**S5933QE PCI**  
**Controller Device**  
**Summary**

## PCI S5933QE Matchmaker Device Summary Revision 2, November 1, 1997

The following are all known device and document variations for the AMCC S5933QE PCI Matchmaker and 1997 device data book. The workarounds described below are factory suggestions and are not to imply the only or all possible solutions. Contact your local Field Application Engineer for new workaround developments. Also contact your FAE for the latest design notes and data book corrections or see the AMCC home page at [www.amcc.com](http://www.amcc.com).

**Figure 1**

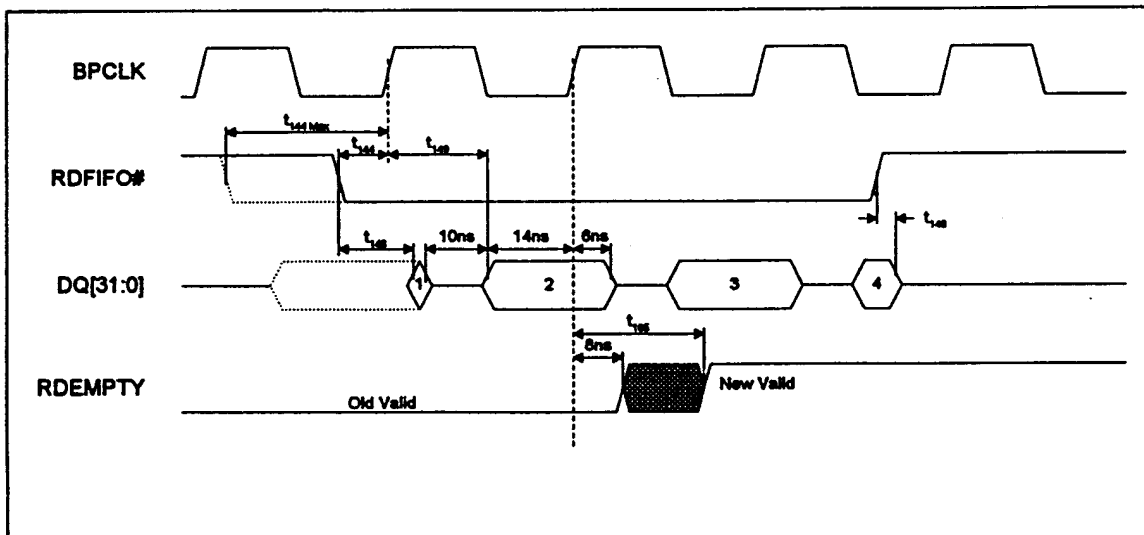
t165 page 13-11            for QC=15ns    RDEMPTY valid from BPCLK rising edge  
                                 for QE=12ns

FIFO read: When PCI to Add-on FIFO is empty, RDEMPTY is asserted 12ns max after the rising edge of BPCLK.

As RDFIFO# requires an 8ns setup, this gives 10ns to de-assert this command before the next BPCLK edge.

**Figure 2**

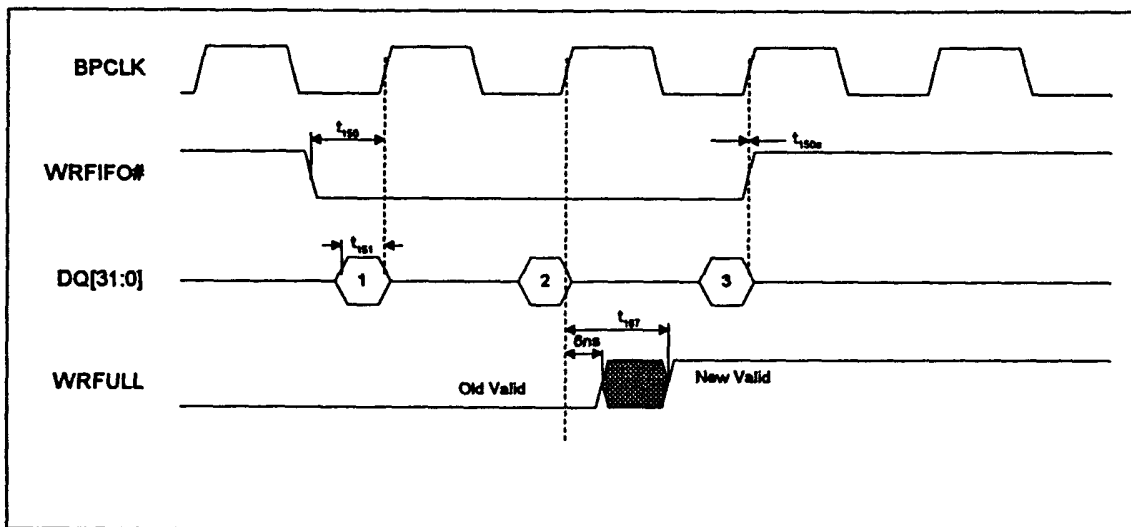
t167 page 13-12            for QC=17ns    WRFULL valid from BPCLK rising edge  
                                 for QE=11ns

FIFO write: When the Add-on to PCI FIFO is full, WRFULL is asserted 11ns max after the rising edge of BPCLK.

As WRFIFO# requires a 12ns setup, this gives 7ns to de-assert this command before the next BPCLK edge.
